8.5 Kingsford Smith Reserve Master Plan - Adoption

**Submission on the Kingsford Smith Reserve Master Plan
document on public exhibition.**

Kingsford Smith Reserve Draft Master Plan - Have Your Say

C:\Users\Mick\OneDrive\2021 - SEAGULLS\PROPOSED CHANGE ROOMS.dwg, 18/08/2021 11:31:51 AM, 1:154.772

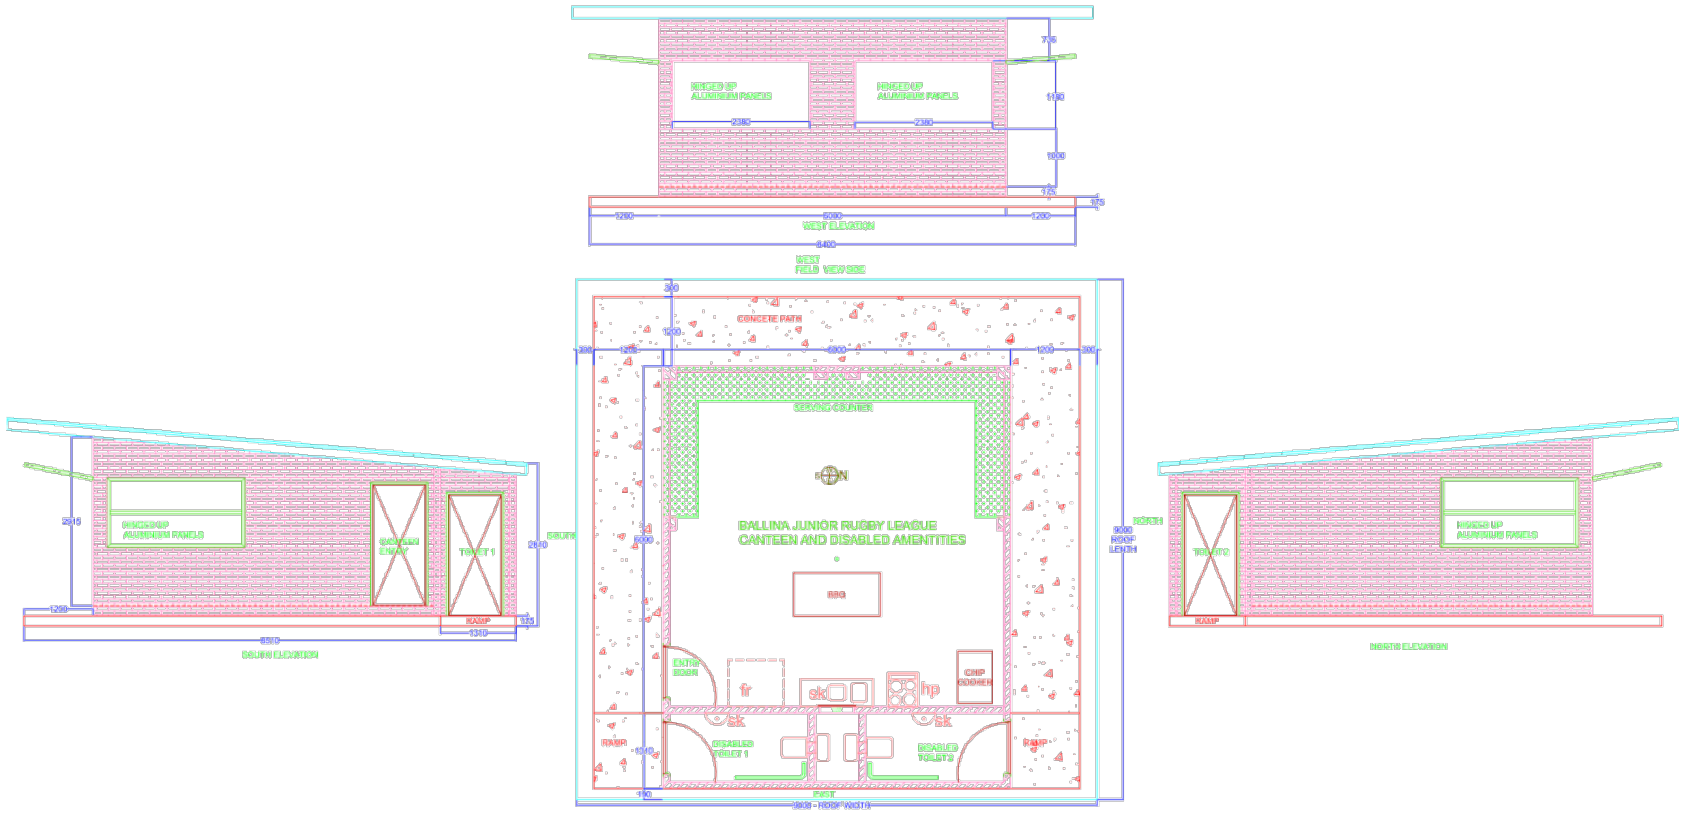
We said we needed 4 new changerooms to meet the NRL standard at least 8m x 8m rooms with over 3m high clearance.
The location shown on the master plan would remove all our southwest spectator's viewing area and cut off our access to the southern hill.
There is no mention of improving the juniors playing and training grounds, we need 4 fields set up with proper lighting and goalposts.
We need a Juniors toilet block and canteen, we have kids running through the carpark to get to the main clubhouse toilets.
And we are in desperate need of a covered grandstand for our visiting spectators, we have no shaded or wet weather covered areas for the opposition teams.
On our eastern hill spectator area, we also have no permanent shade or covered areas.
